COMMONWEALTH OF PUERTO RICO
OFFICE OF THE GOVERNOR
PUERTO RICO PLANNING BOARD

Federal Consistency Determination
CZ-2001-0529-117
JPA- 179
198800516(IP-VG)
Villa Marina Yacht Harbour Expansion
Sardinera, Fajardo

APPLICATION BY:
VILLA MARINA YACHT HARBOUR
AT PLAYA SARDINERA, BAHIA
FAJARDO, PUERTO RICO - DATE
Sheet No. 1.0

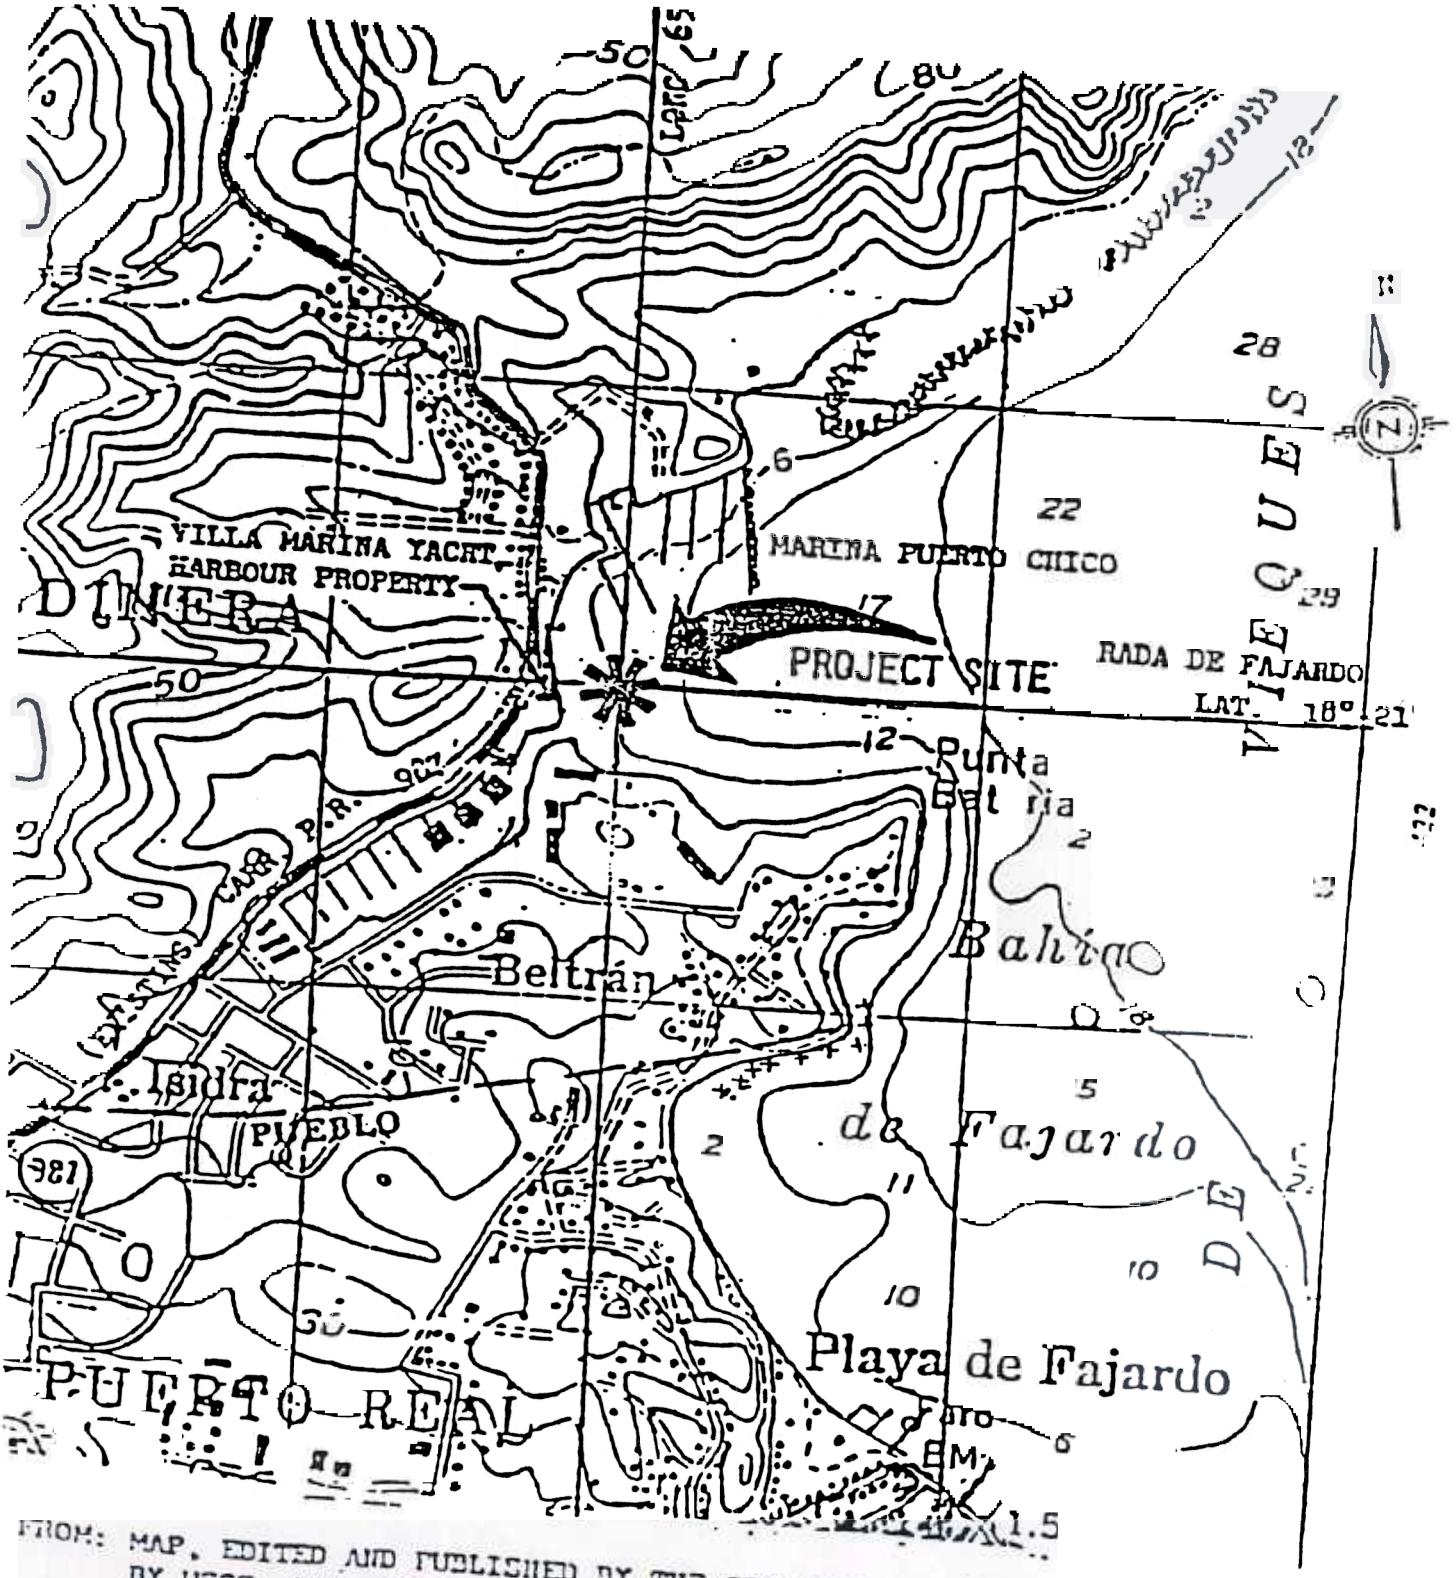
Mr. Richard Vito (Sea Lovers Marina owner) expressed objection to the proposal. He is concerned about the impact that the proposed project will have in his approved marina expansion of 46 slips. He argues that his approved expansion is not being considered and that the project plans submitted by the applicant do not correspond to the real dimensions of the Sardinera Bay. The most recent submitted project plans and drawings did not contain the correct distances between the aproved Sea Lovers espansion and the new Villa Marina proposal. He expressed concerns about the restriction of space and increase in hazard to navigation because of the presence and location of the new breakwater and facilities among others. He also raised many issues related to the viability of the new breakwater.

The Explanatory Memo states that proposed fueling facilities have been removed yet the enclosed drawing of the memo show a fuel dock at the entrance channel to Villa Marina. The memo also states that sewage pumpout facilities will be provided on the new pier, but the enclosed drawings do not indicate the location of these facilities. The discrepancies in the written memo and enclosed drawings should be clarified.

1- The project plan shall be reviewed in order to include all the required information to evaluate the proposal and adress the issues raised by Mr. Richard Vito. The project Plan shall include the bathymetry of the area and the correct dimensions of the Sardinera Bay. We recommend you to consult with the USACE representatives about the information that is required to include in the drawings.
